ADDENDUM NO. 03

DATE: May 5, 2020

PROJECT: Inglemoor High School Concert Hall + Music Building Project

SHEET A9.12 – Enlarged Stair Plans & Sections – Stair B

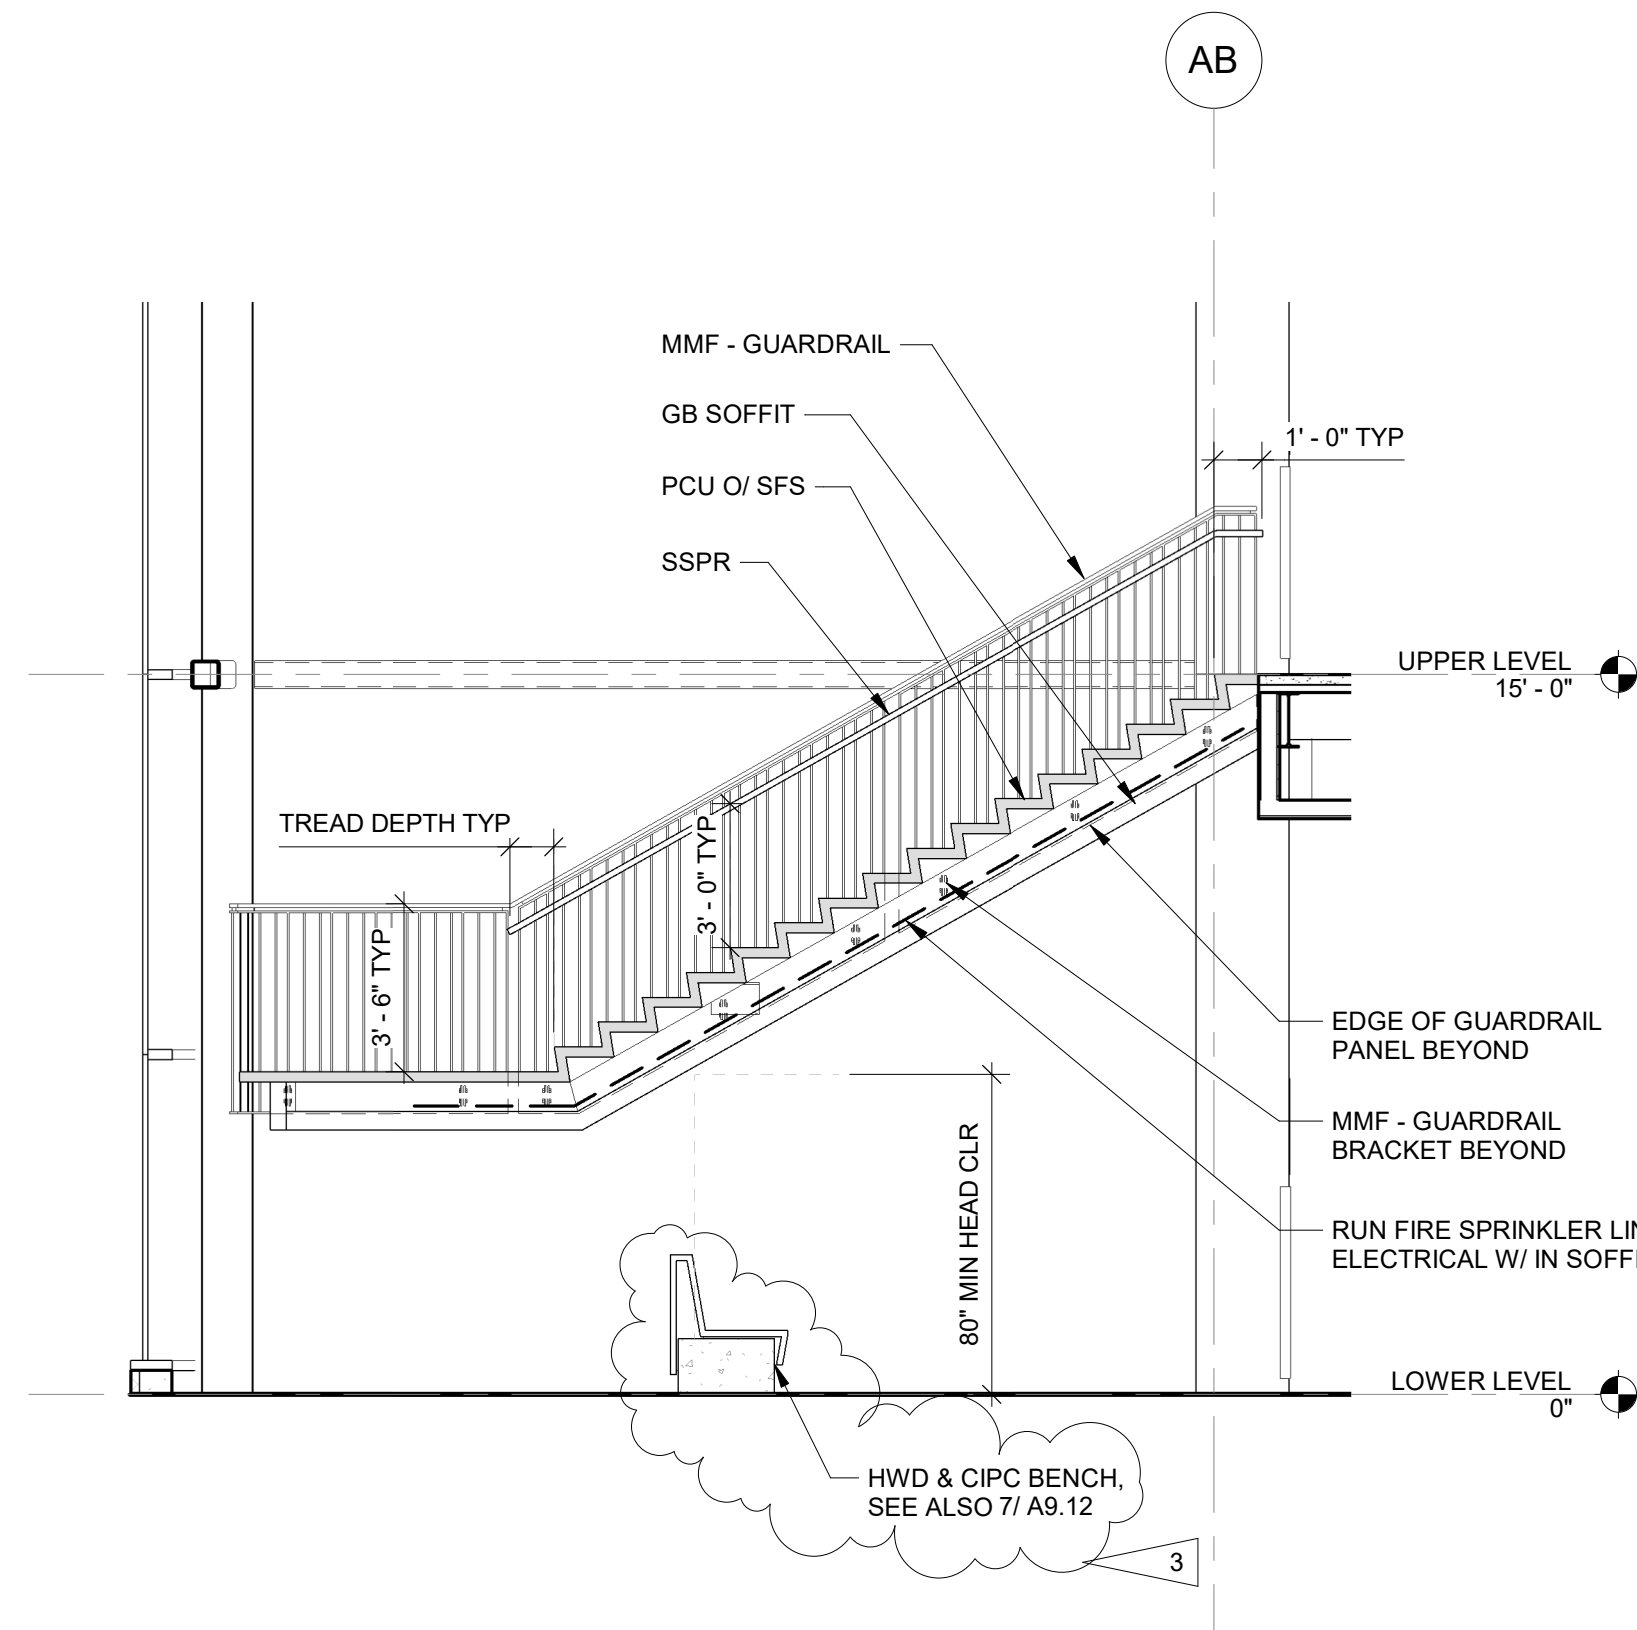
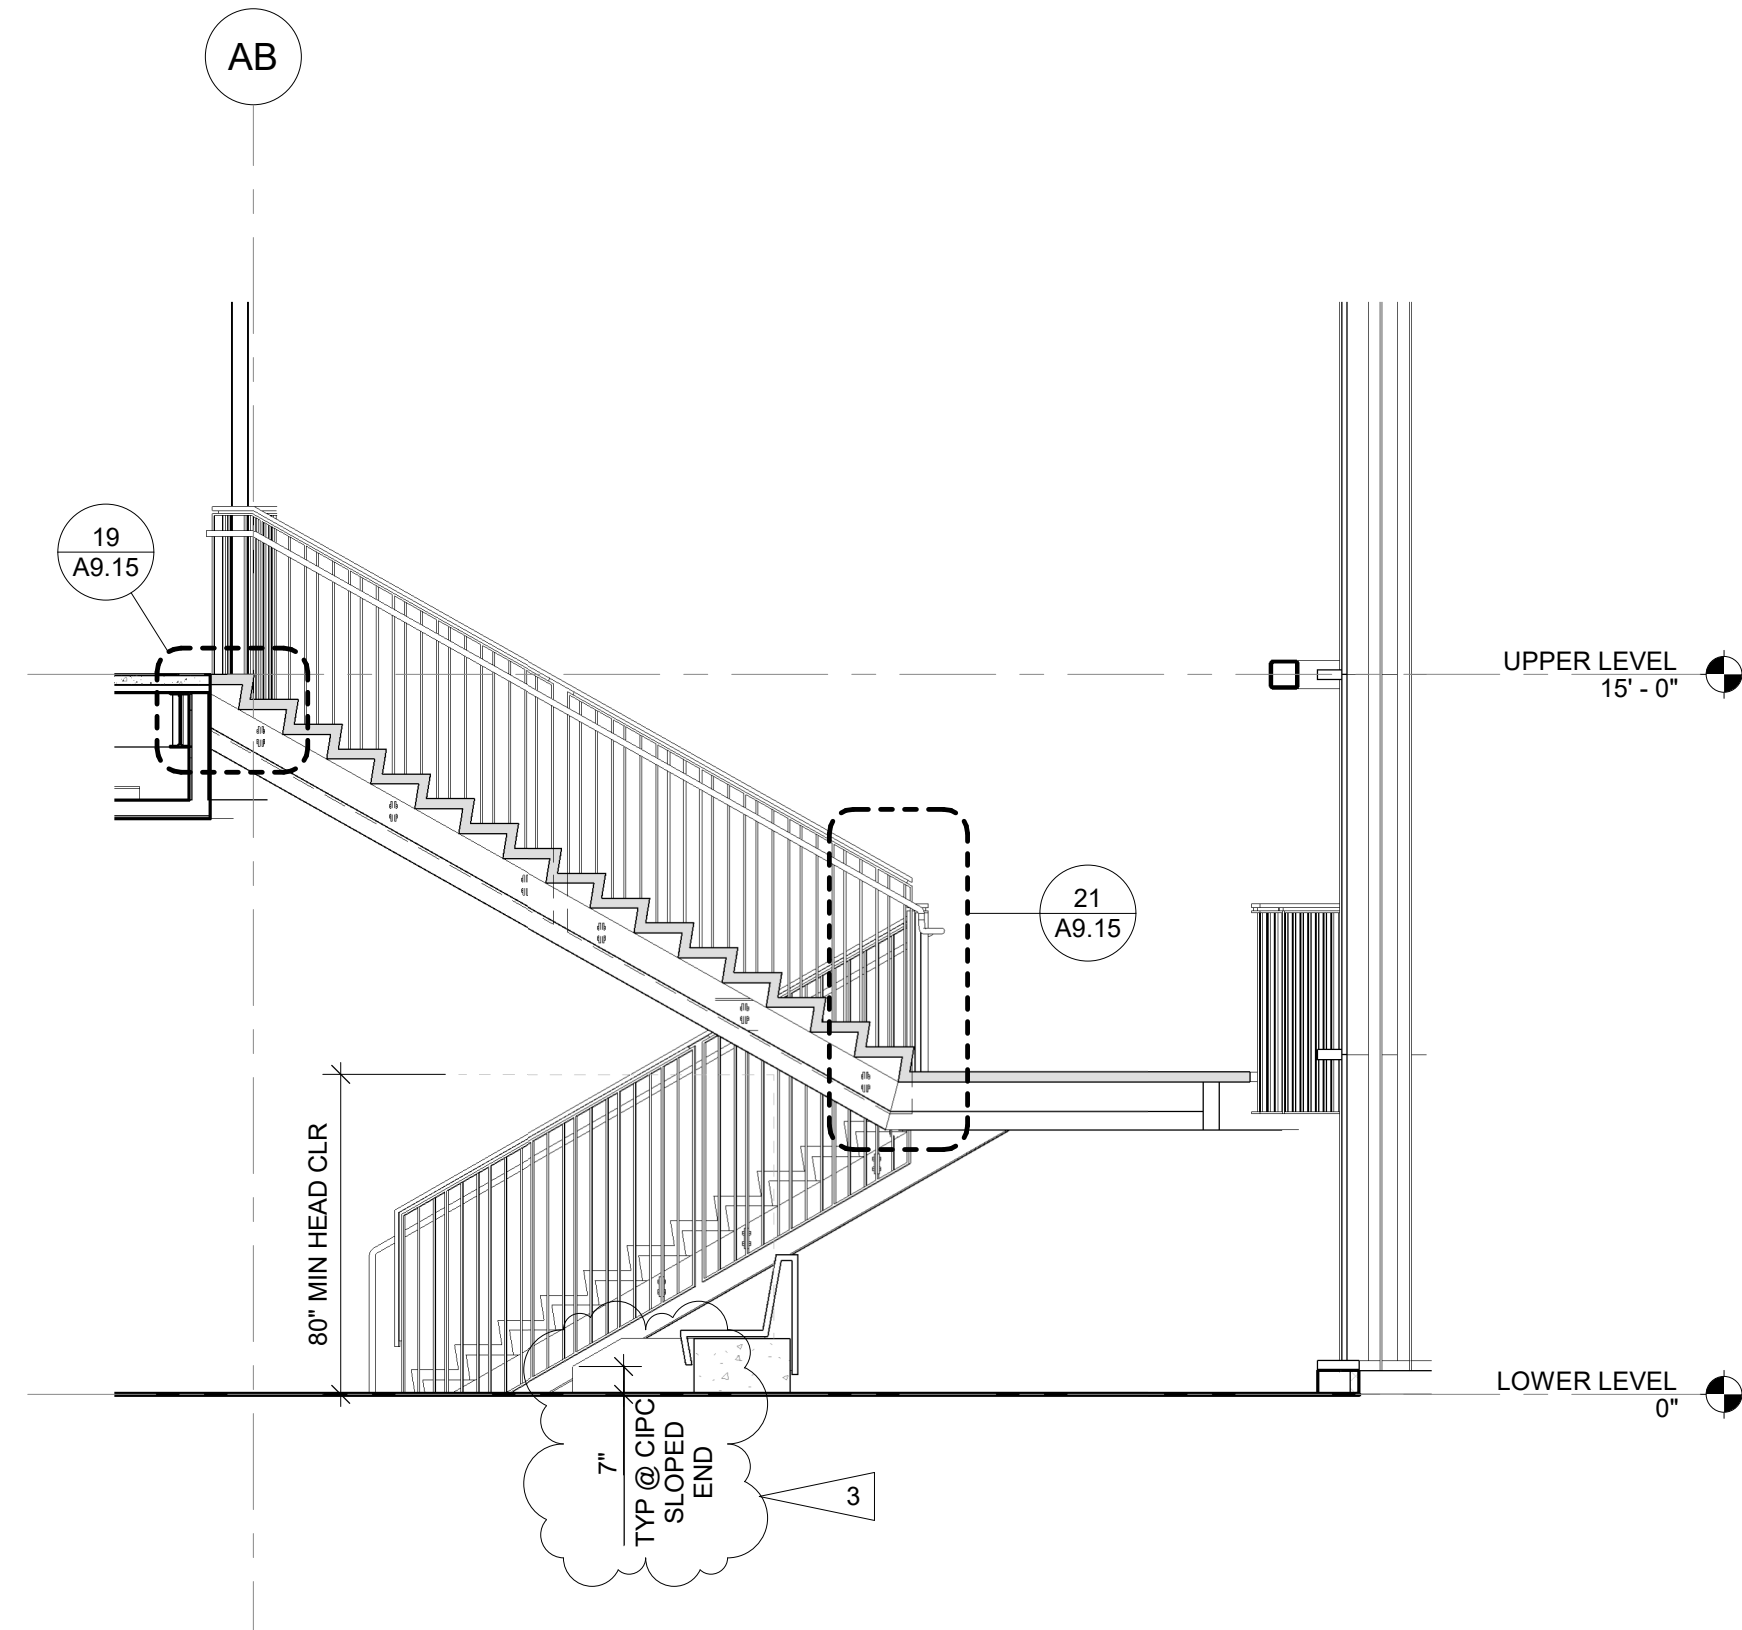
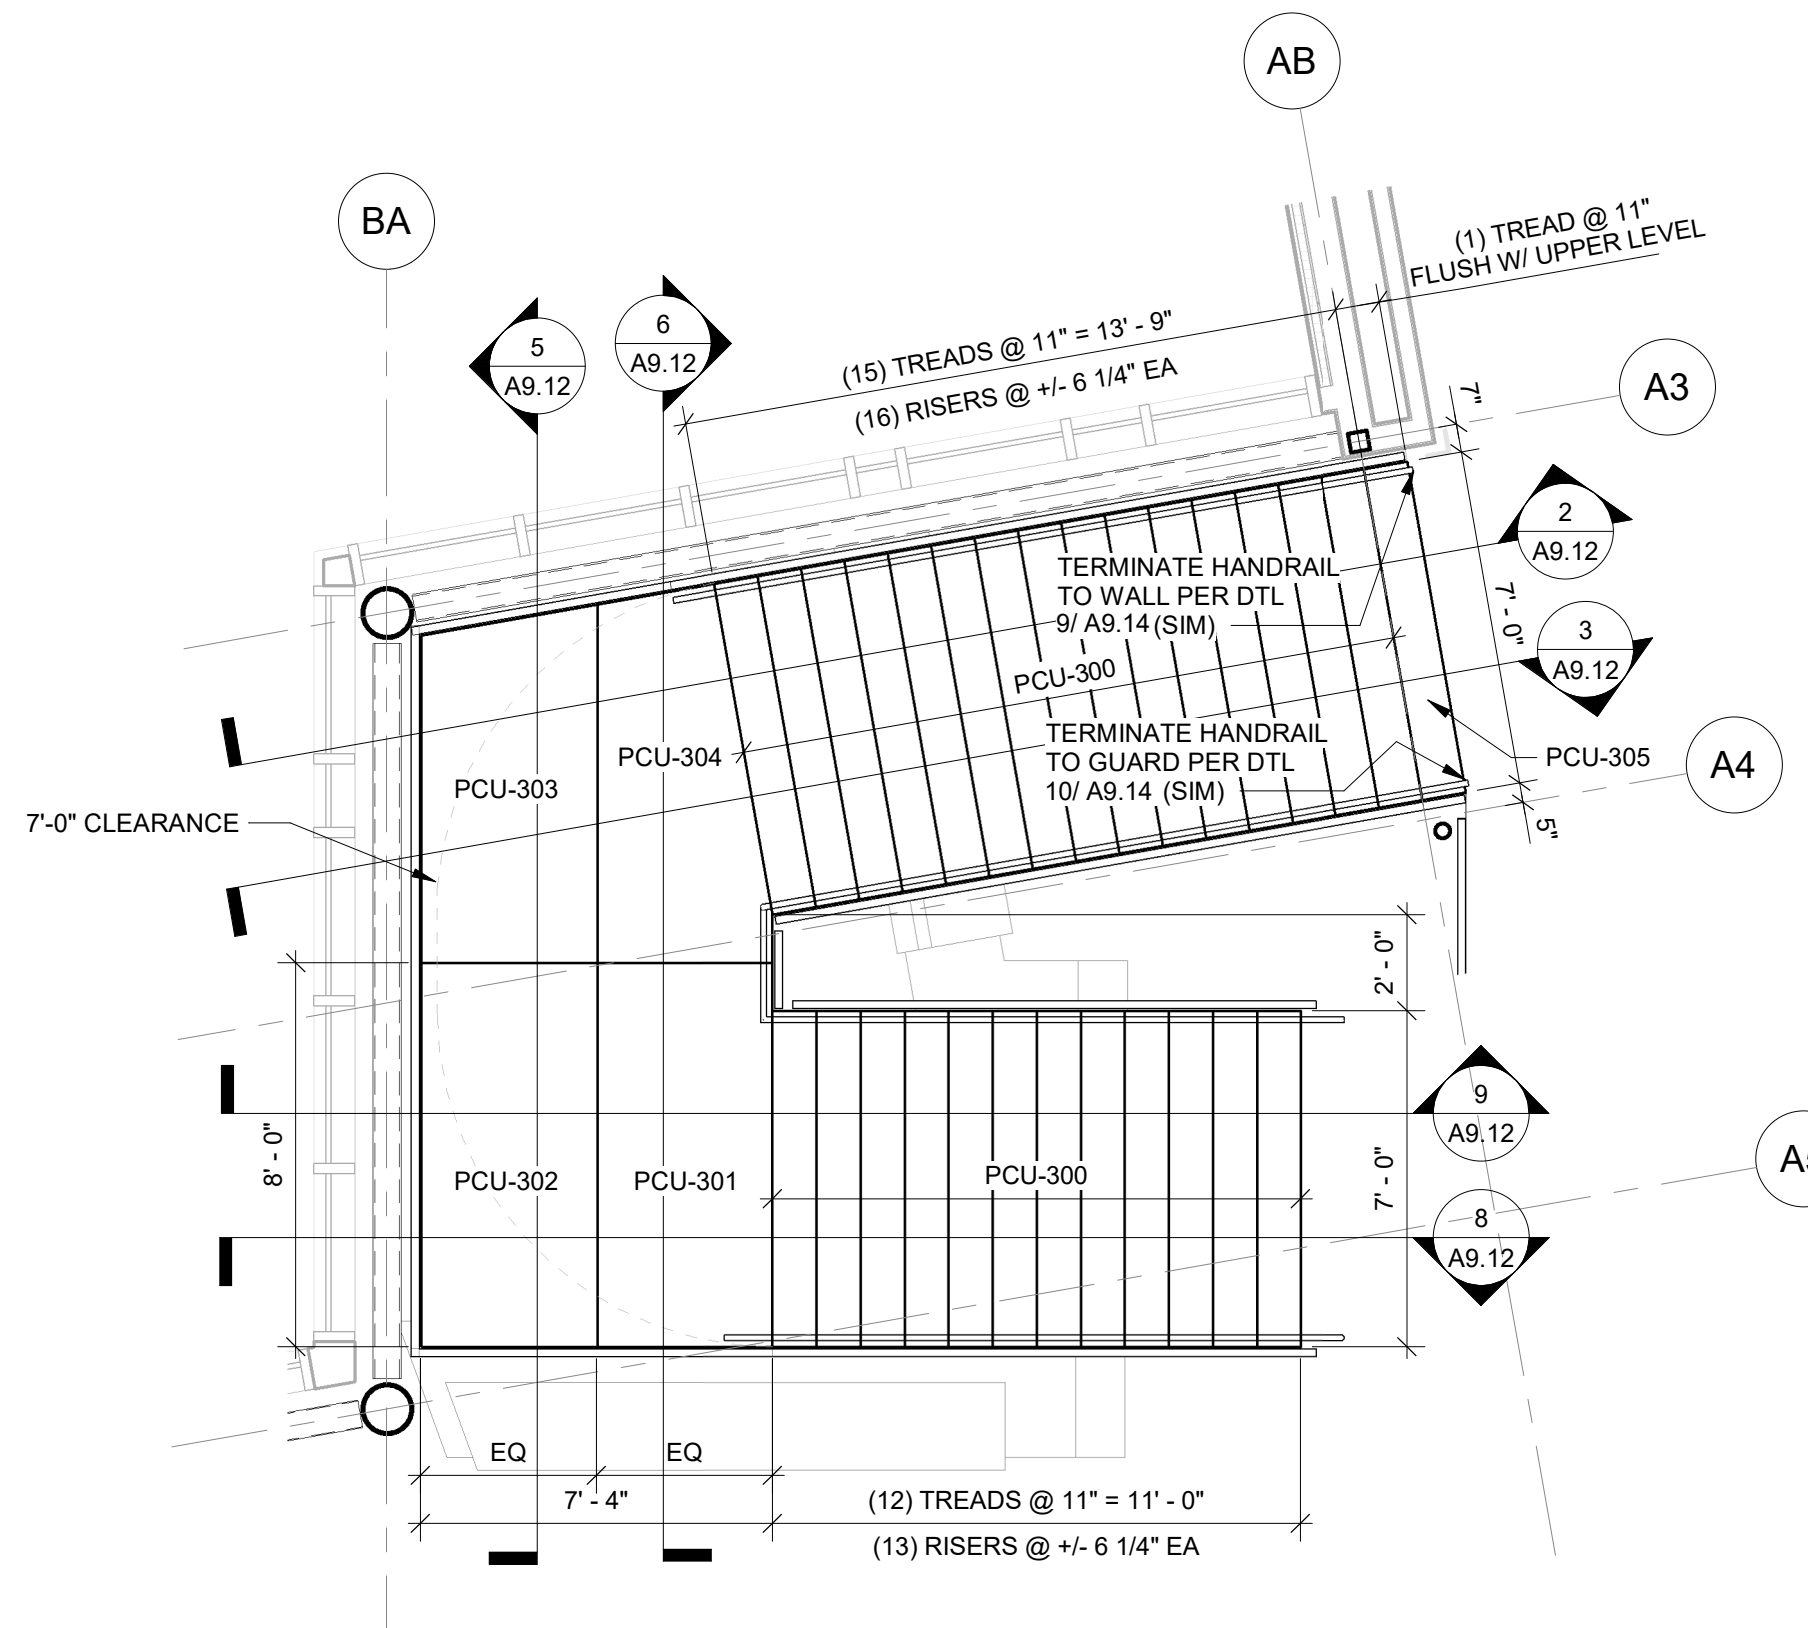
1. On Detail 2, 3, 5, 6, 7, 8, and 9, REVISE per attachment A4.46
